FED. ROAD DIST. NO.	STATE	FED. AID PROJ. NO.	FISCAL YEAR	SHEET NO.	TOTAL SHEETS
HAWAII	HAW.	HSIP-056-1(53)	2010	ADD.3	18

9/13/10	 Amend General Note No. 6
	 Add General Note No. 17
DATE	REVISION
STATE OF HAWAII DEPARTMENT OF TRANSPORTATION HIGHWAYS DIVISION	
GENERAL NOTES AND LEGEND	
KUHIO HIGHWAY SAFETY IMPROVEMENTS	
Mile Post 2.98 to Mile Post 5.07	
Federal-Aid Project No. HSIP-056-1(53)	
Date: Sept. 2010	
SHEET No. 1 OF 1 SHEETS

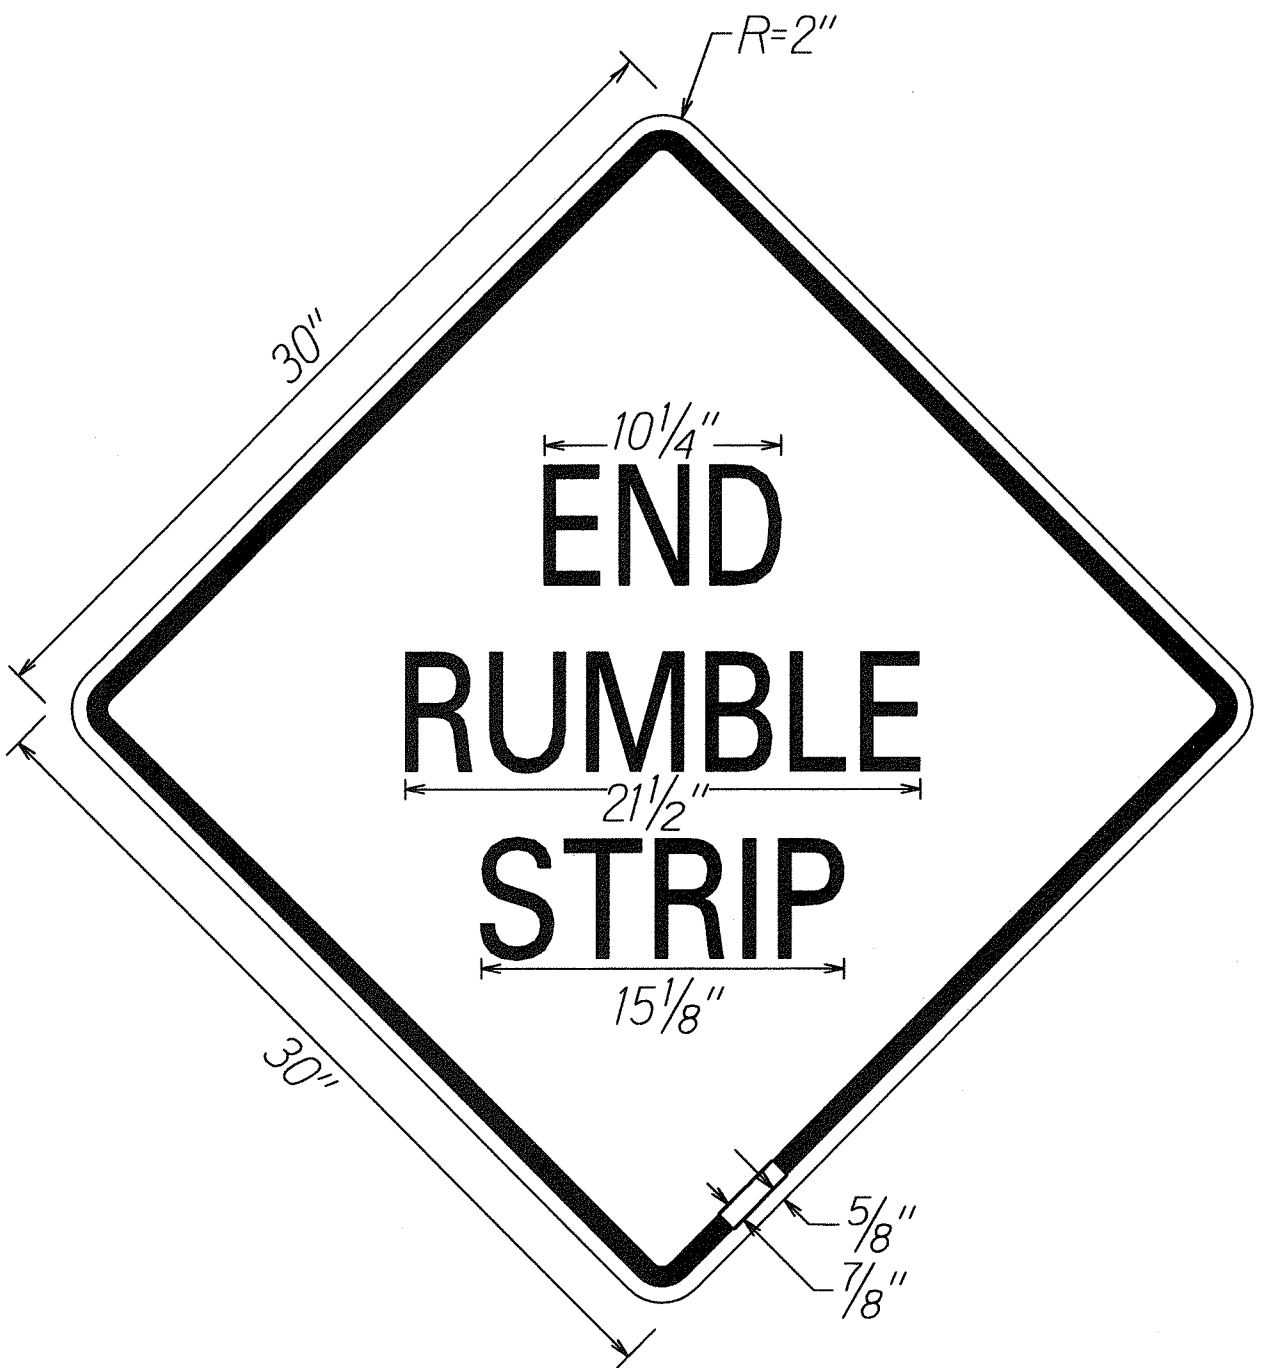
9/13/10	<div><div>1</div><div>Delete Sign Note No. 10</div></div>
DATE	REVISION
STATE OF HAWAII DEPARTMENT OF TRANSPORTATION HIGHWAYS DIVISION	
RUMBLE STRIP SIGN DETAILS AND NOTES	
KUHIU HIGHWAY SAFETY IMPROVEMENTS Mile Post 2.95 to Mile Post 5.07 Federal-Aid Project No. HSIP-056-1(53)	
Date: Sept. 2010

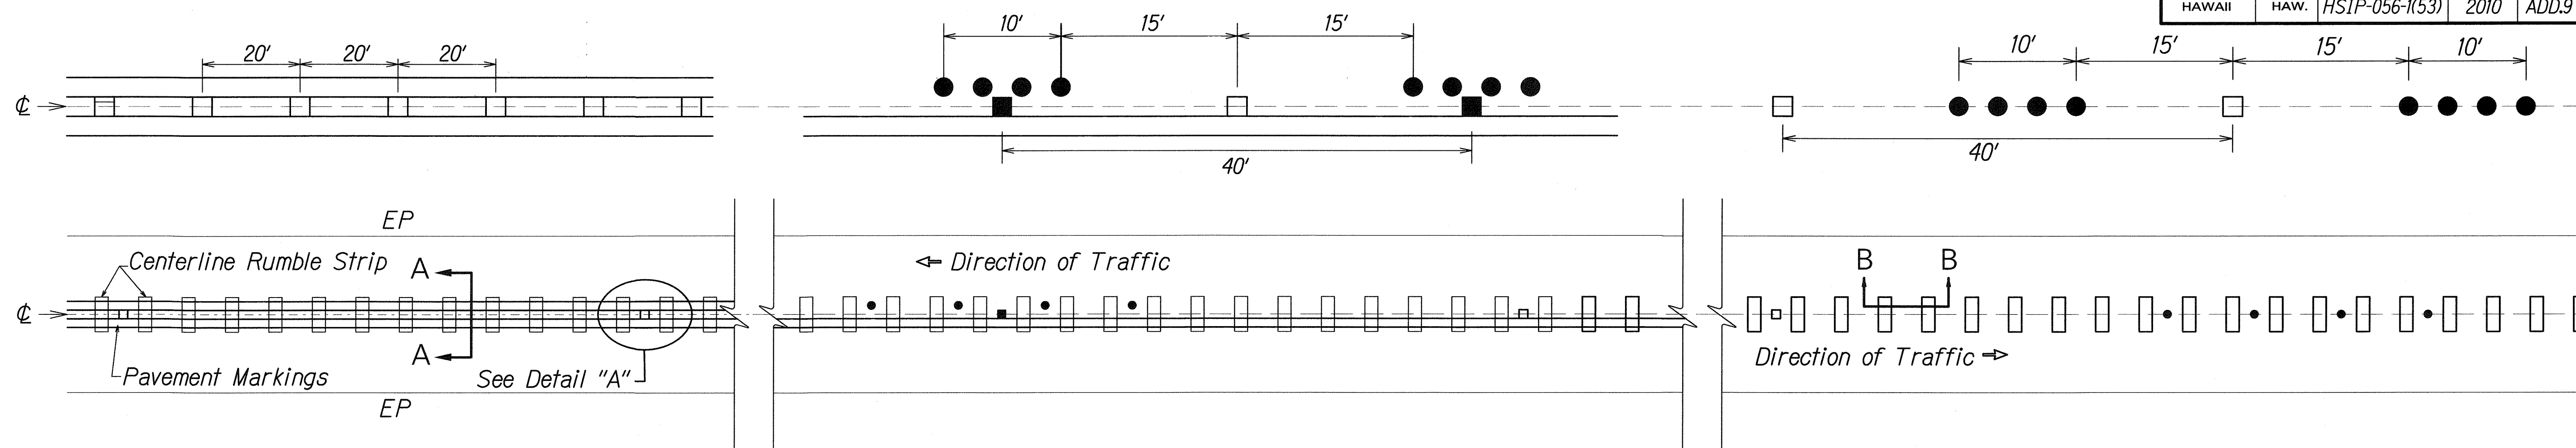
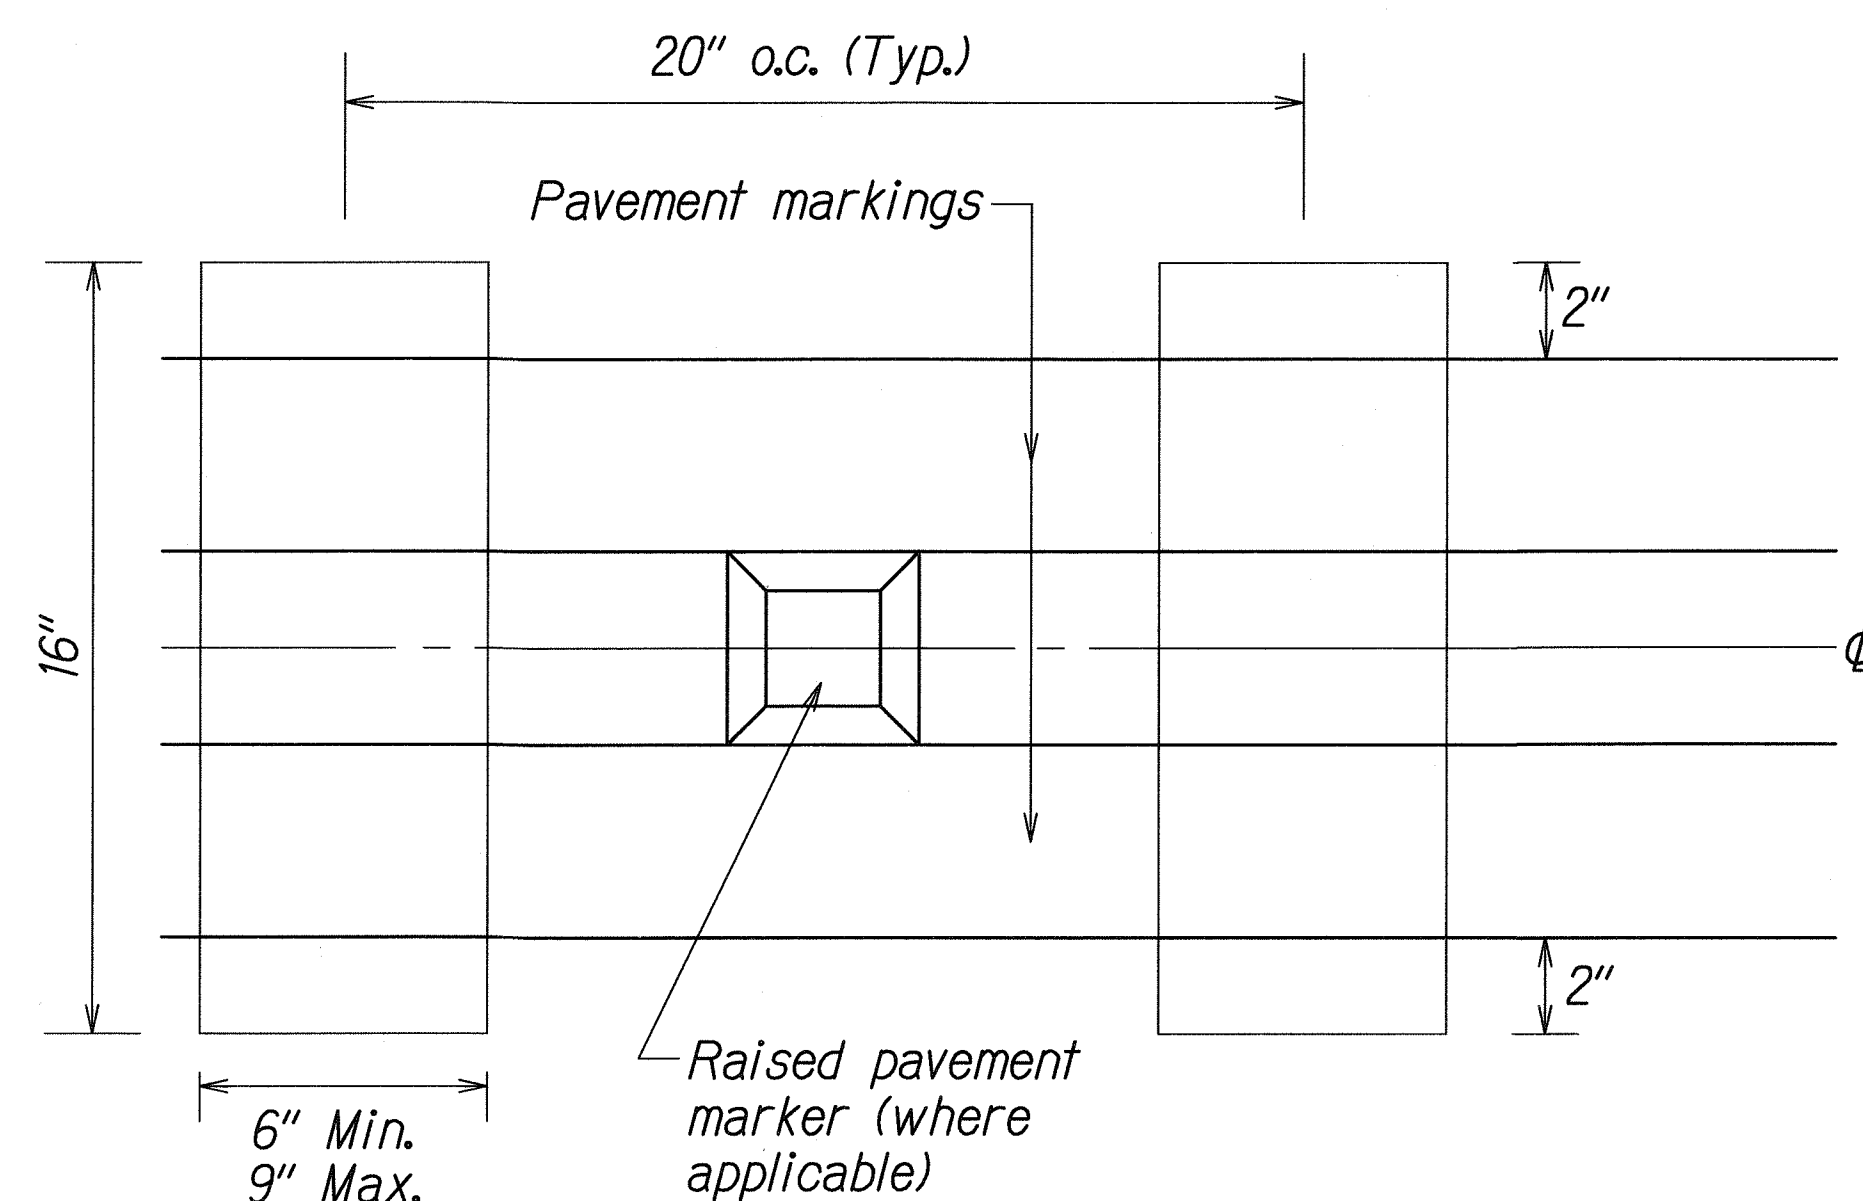
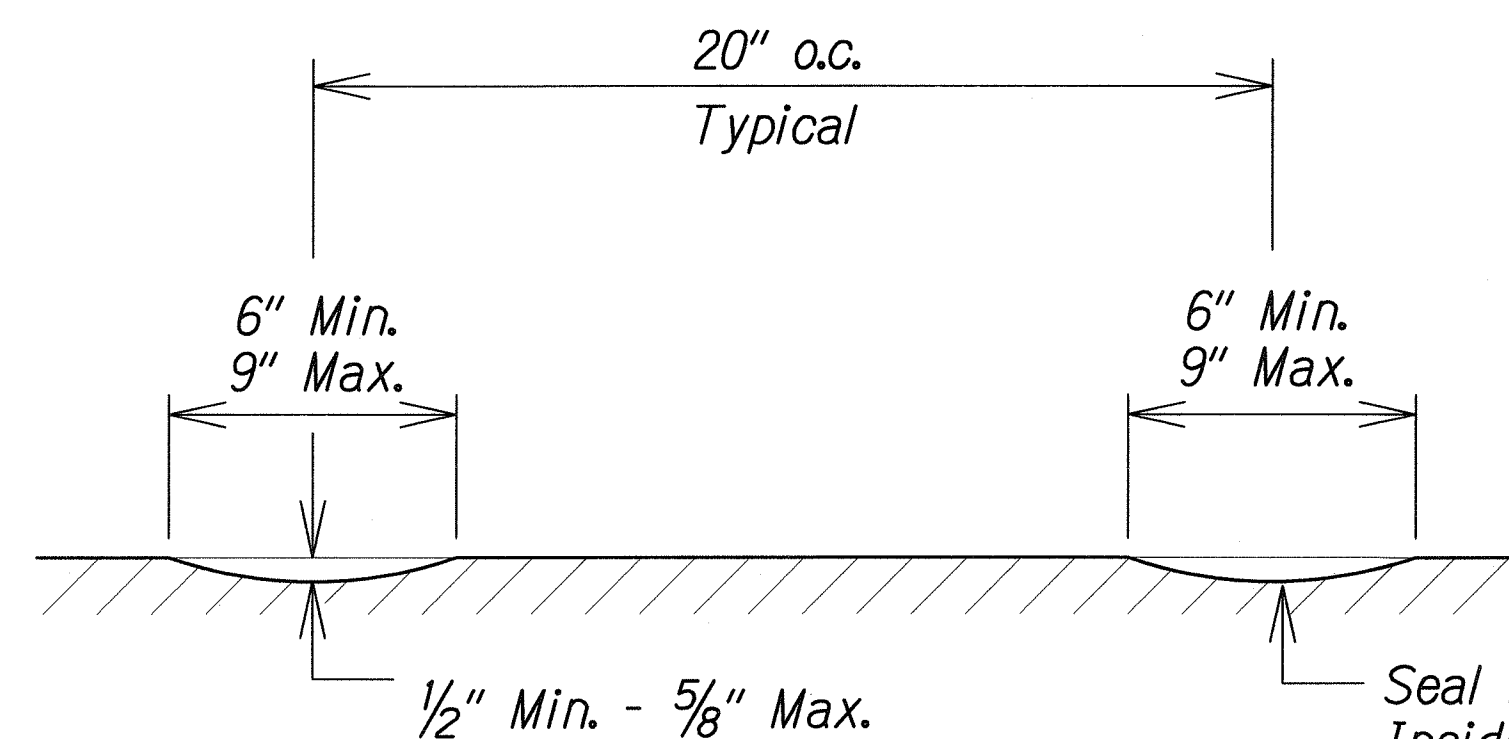
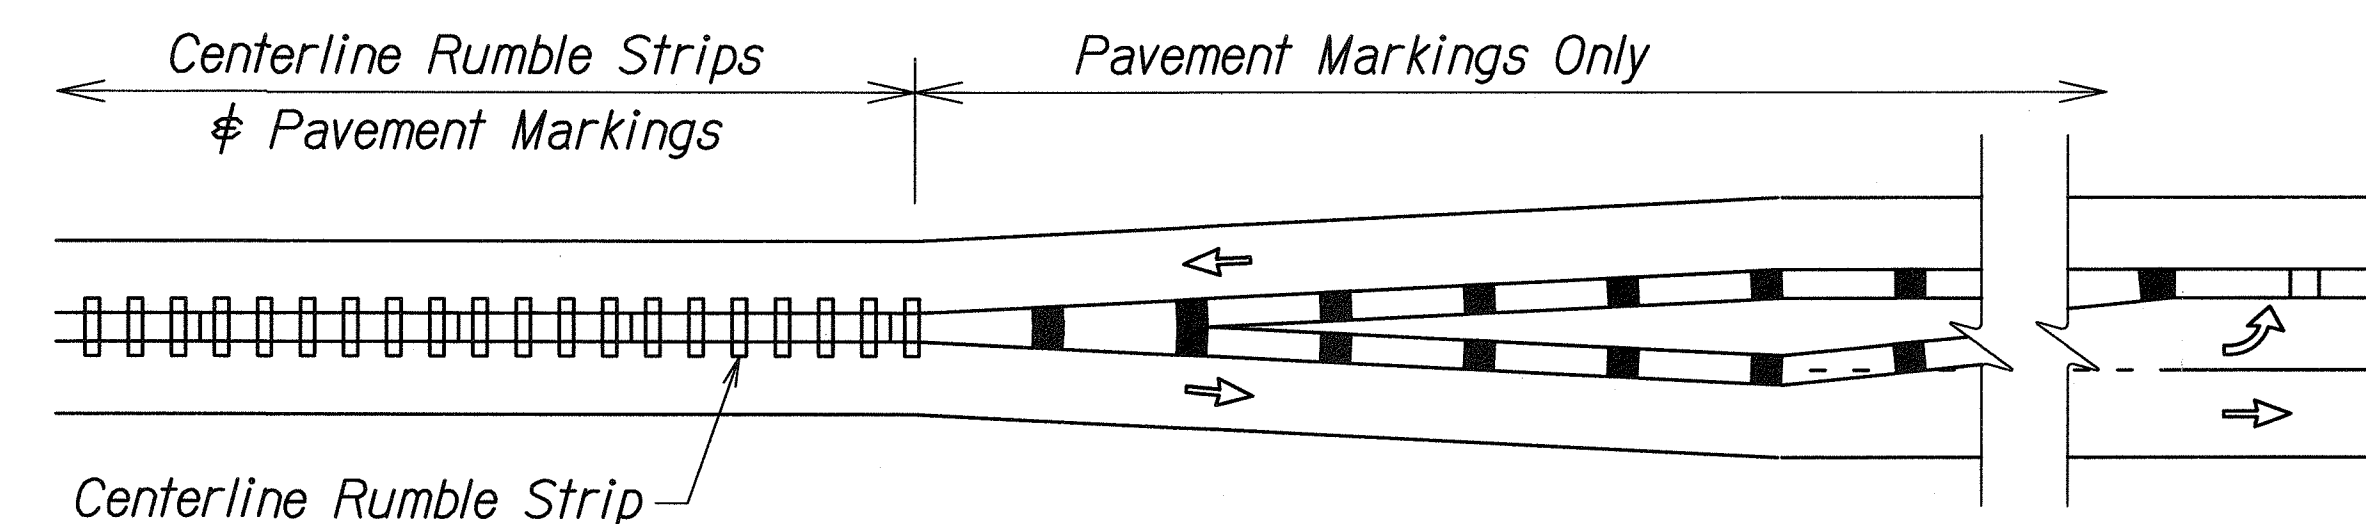
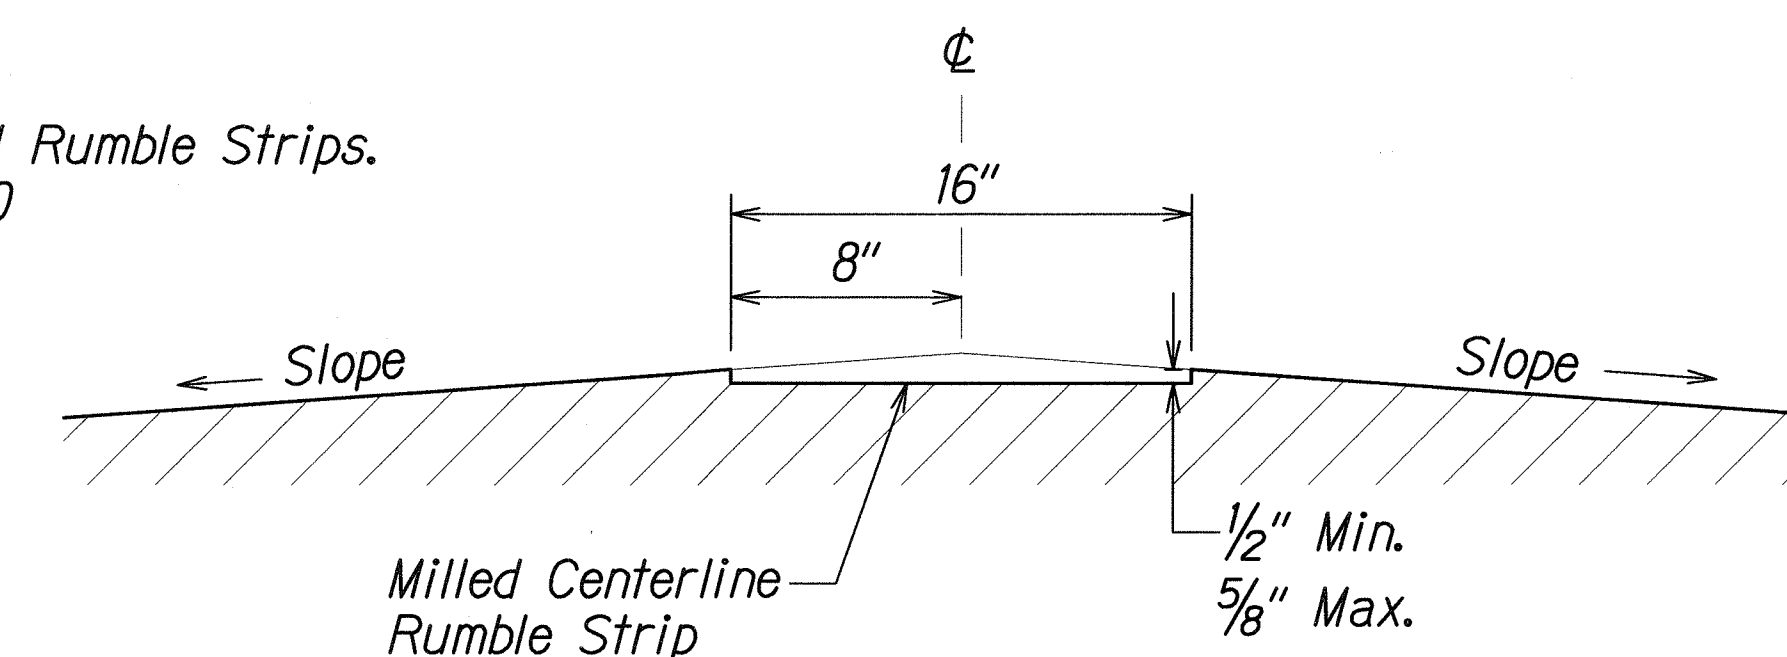
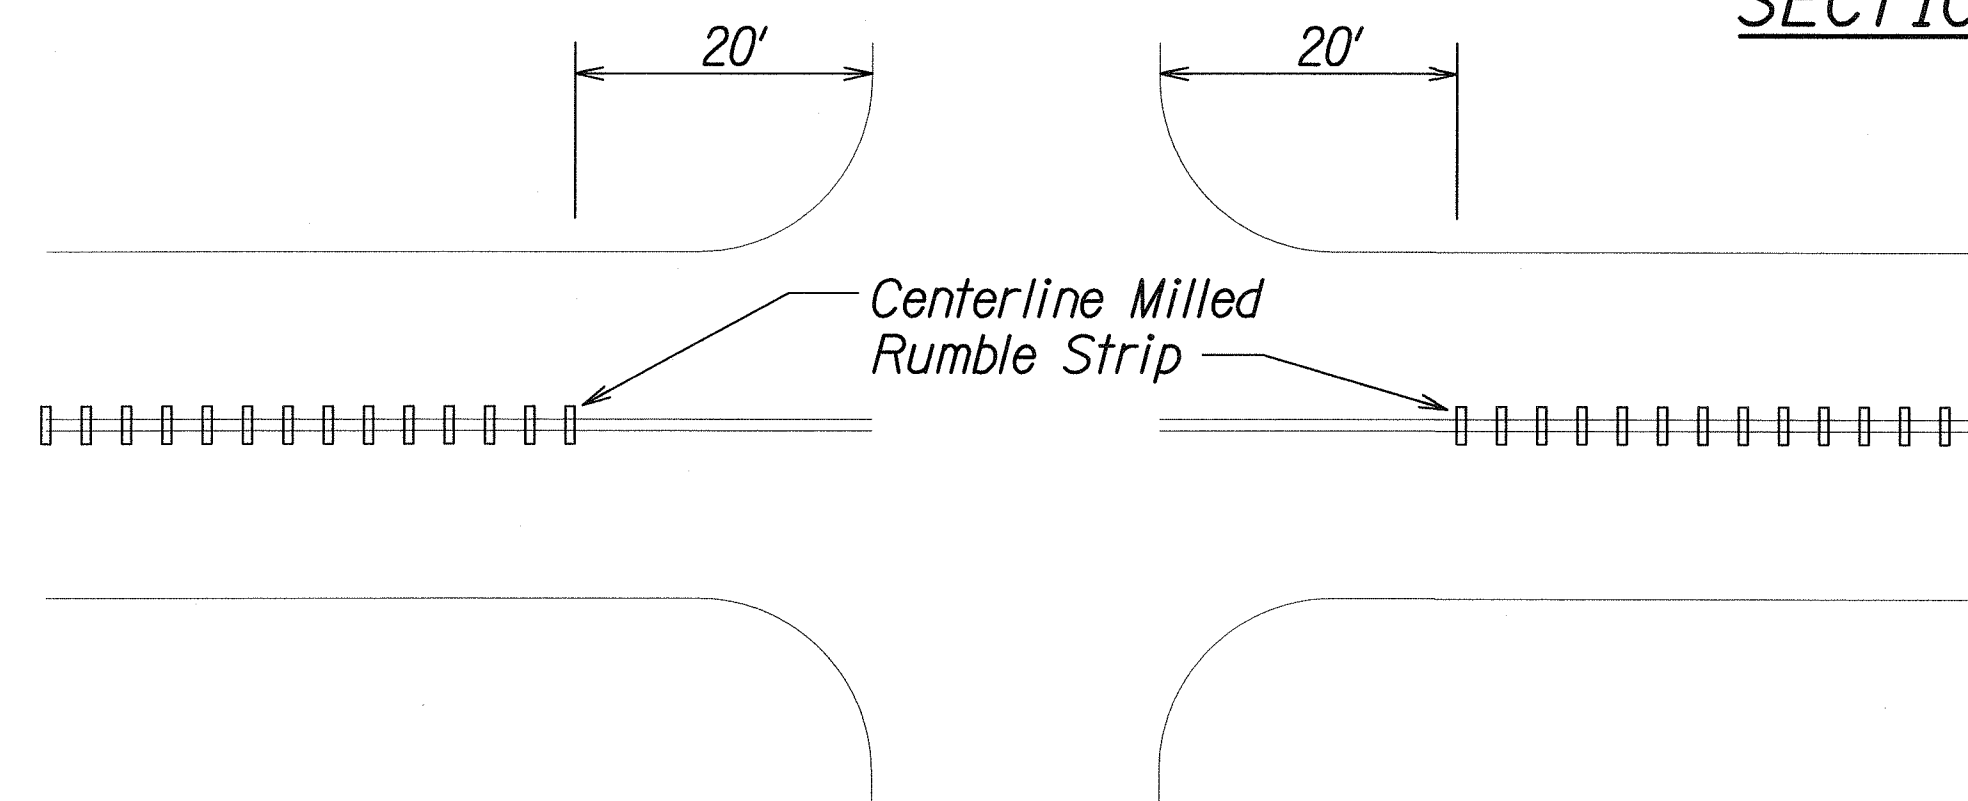
9/15/10	<div>1</div>	Delete Note No. 10
DATE	REVISION	
STATE OF HAWAII DEPARTMENT OF TRANSPORTATION HIGHWAYS DIVISION		
<u>CENTERLINE MILLED</u> <u>RUMBLE STRIP DETAIL</u>		
<u>KUHIO HIGHWAY SAFETY IMPROVEMENT</u> <u>Mile Post 2.98 to Mile Post 5.07</u> <u>Federal-Aid Project No. HSIP-056-1(53)</u>		
Scale: As Shown		Date: Sept. 2010
SHEET No. T3		OF 12 SHEETS
